RFP 1119-25P

Addendum 001 Issued February 20, 2025

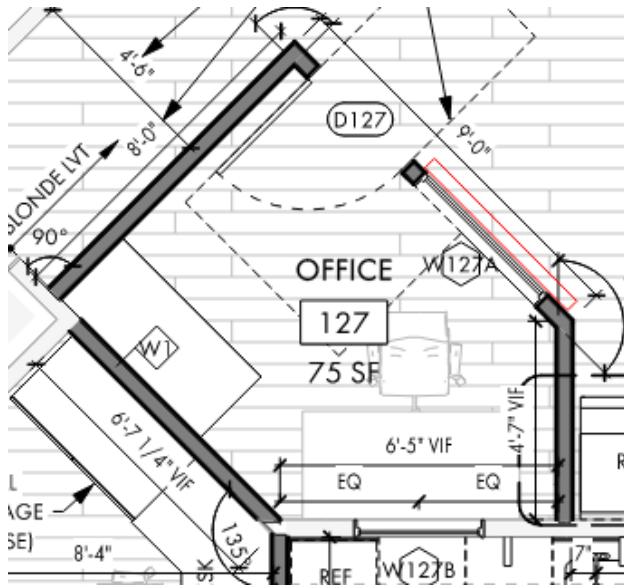
3. During the pre-bid walk, it was observed in Flex Room 128, there is an existing base board heater on the wall where the Food Prep Area is proposed. In reviewing the demo sheets (including MPE's) we have not been able to locate where it is called out to remove the existing fixture and where to terminate it to. For bidding purposes please provide scope for existing fixture. Please see the photo below:

Assume the heater will be relocated to under window 127A. See the sketch in this answer.
